Council assessment of Clause 4.6 request to vary height of buildings development standard

Visual representation of height offset

Figure 1: Roof plan - location and size of non-complying elements (outlined in red)

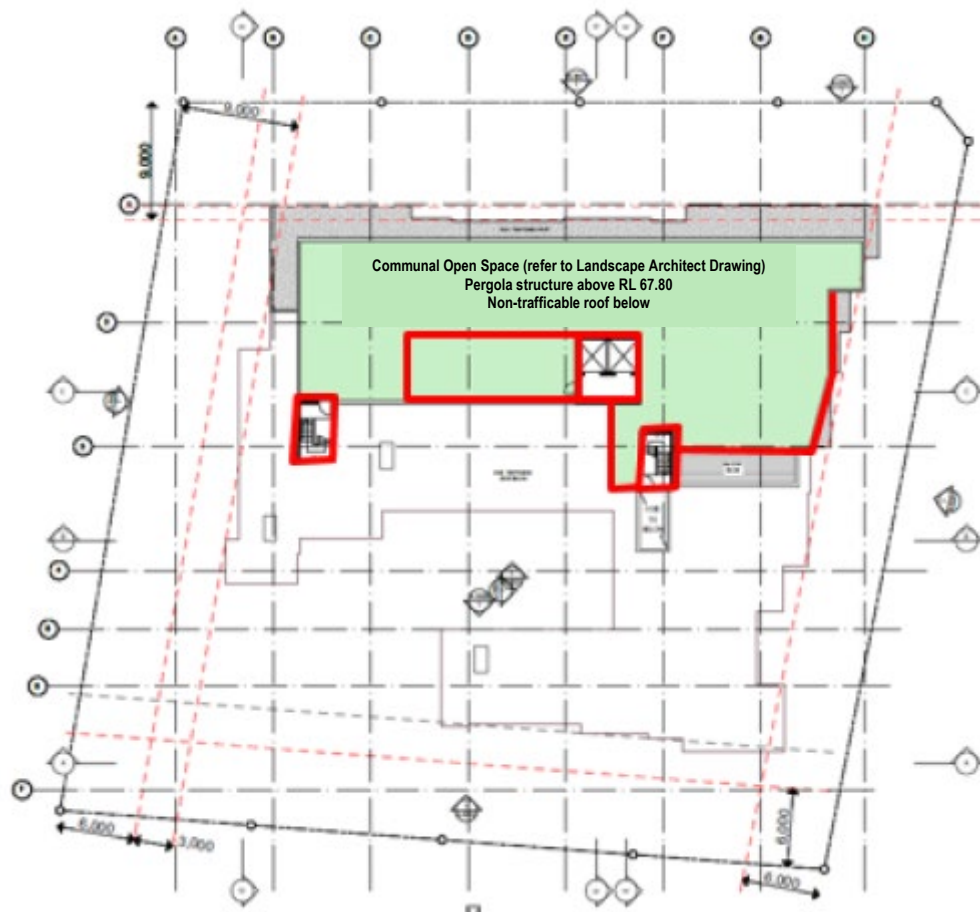
- With regard to the proposed building, the parts of the proposed building envelope which exceed the height limit relate to the lift overrun, shade structure, 2 stair cores and balustrade/corner roof element over unit 5.05.

- The maximum building height is to the lift overrun at RL 68.6, which represents a variation of 3.6 m or 18%. The remaining points of variation are below this.

Figure 2: Aerial view demonstrating the components of the development which are above (shown in white) and which are below (shown in grey) the 20 m height plane relative to the ground level. Viewed from the south-east.

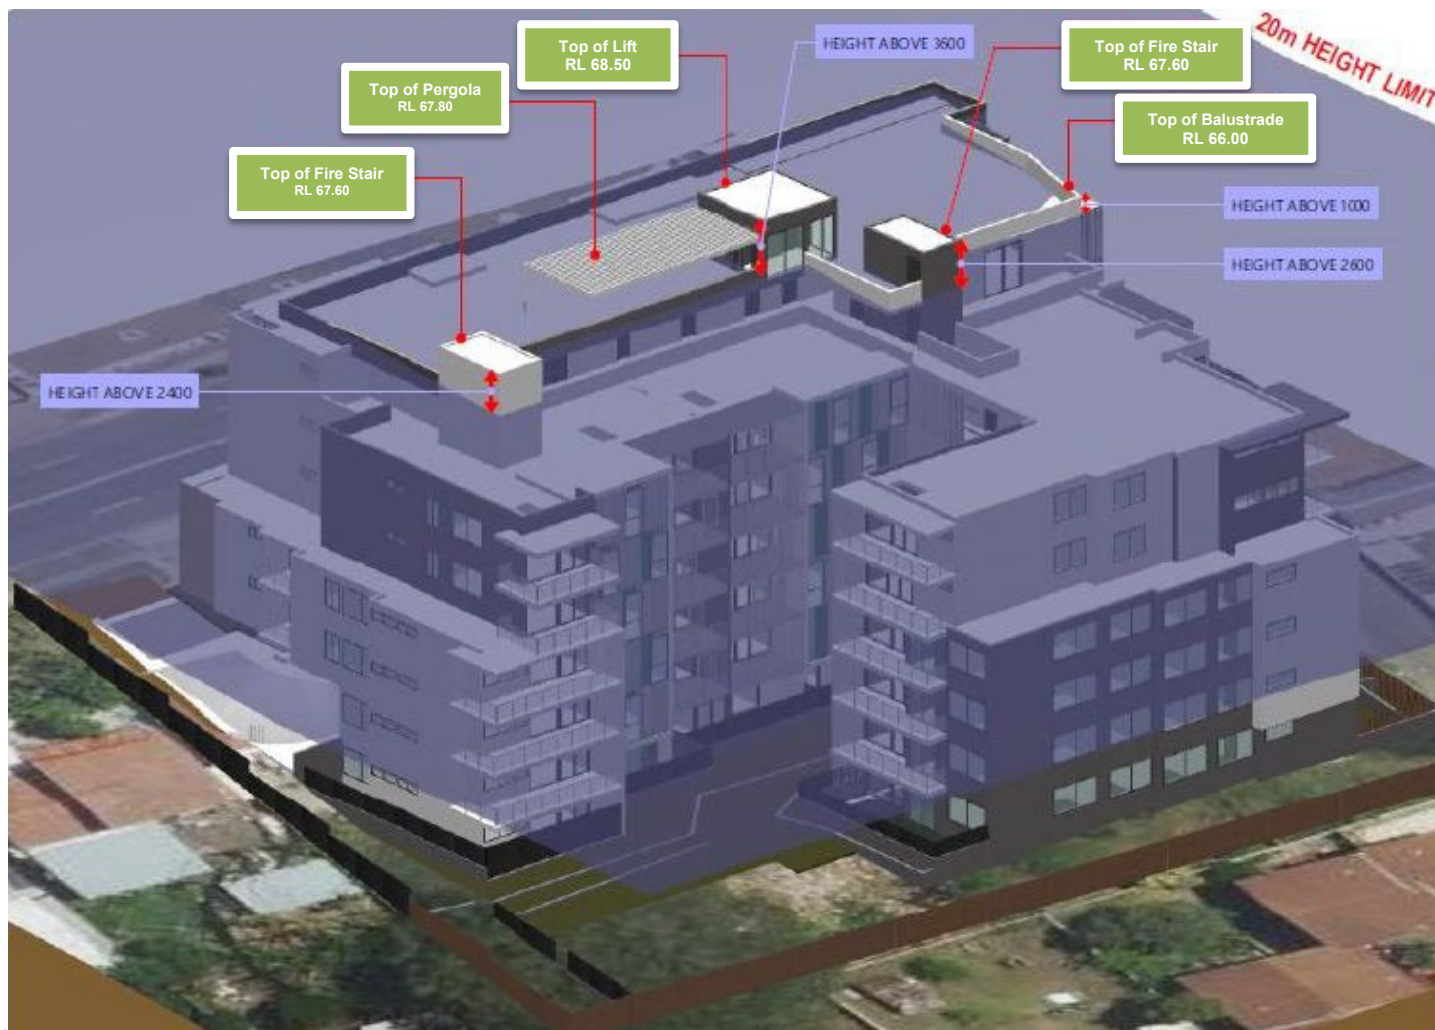
- The stepped building form means that some portions of the building are below the 20 m height limit to compensate for some parts of the building and rooftop plant and equipment above the building height limit.

- The stepped design generates a desirable amenity outcome for future residents and a positive aesthetic streetscape presentation.
- The portions of the roof structures that exceed the height limit do not result in excessive bulk and scale and do not result in adverse shadow and amenity impacts on surrounding properties.

- The lift overrun and stair cores are suitably placed so they are not visible from the street and will not create overshadowing to adjoining properties as shadows are generally in the roof areas.
